WORK COPY

SEWAGE SYSTEM PROFILE & DETAILS

PROJECT: **72 ELGIN ROAD**
BOURNE, MASSACHUSETTS

DRAWING TITLE: **SITE PLAN**
SITE & SEPTIC DESIGN

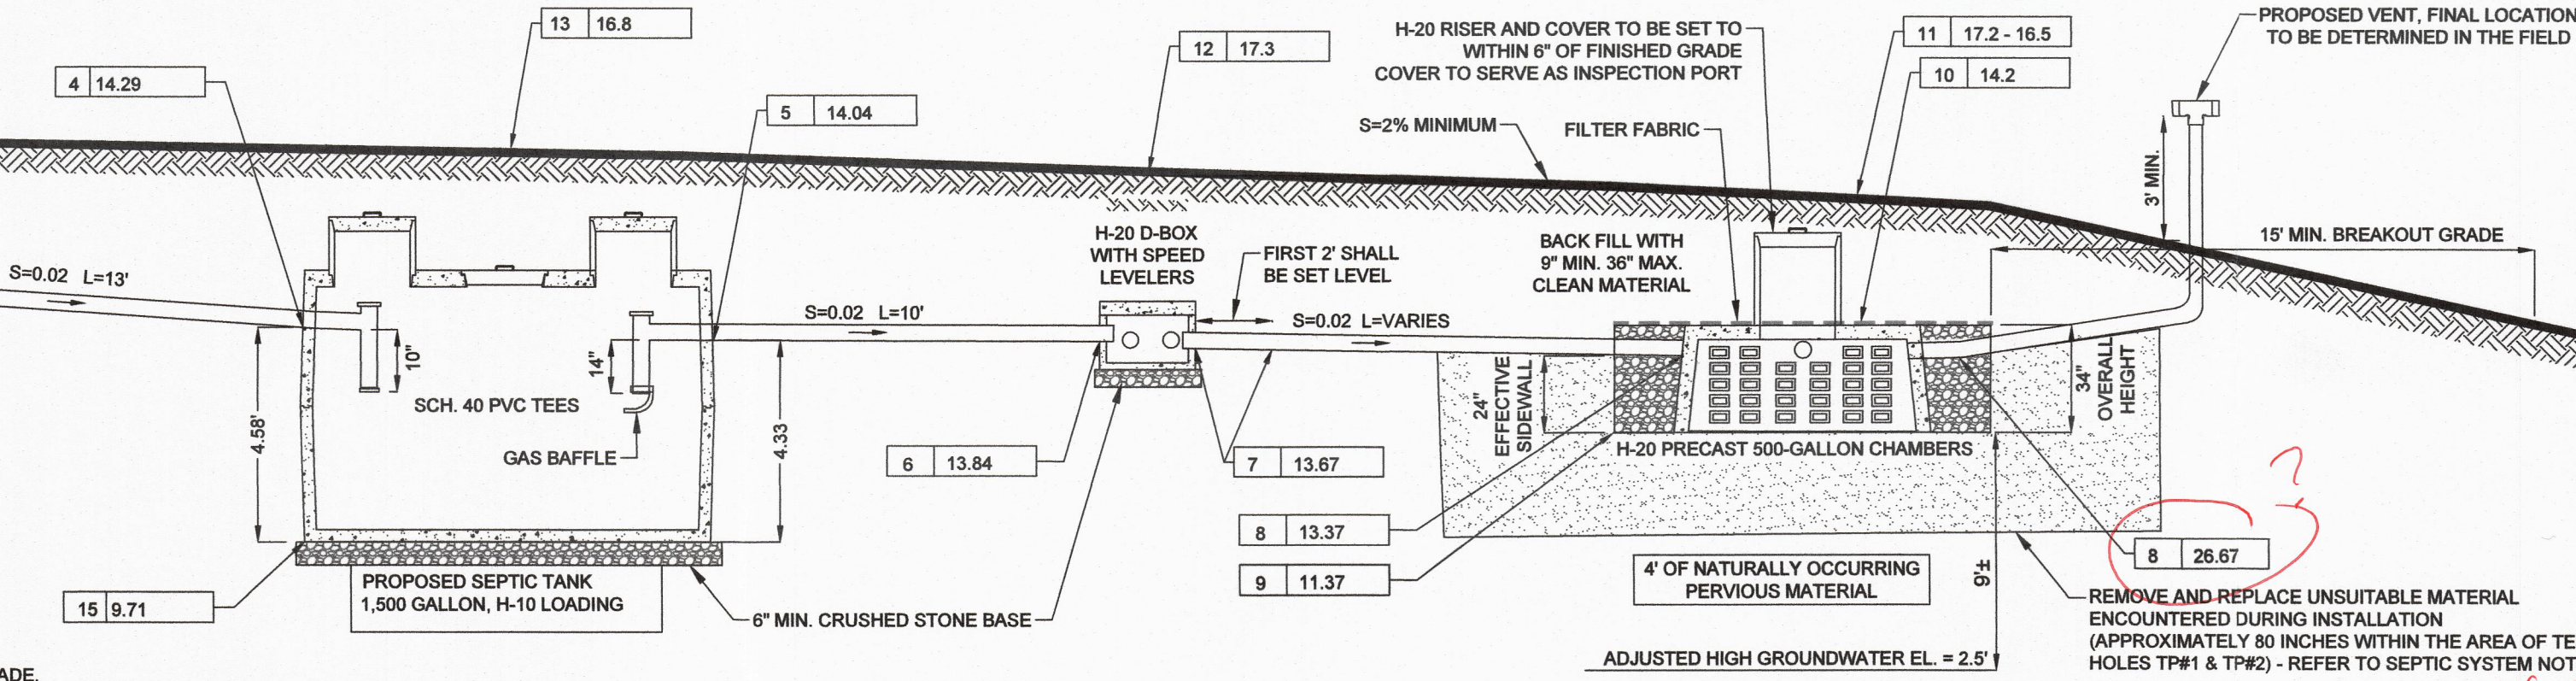
Notify BOH @ excavation to verify soils
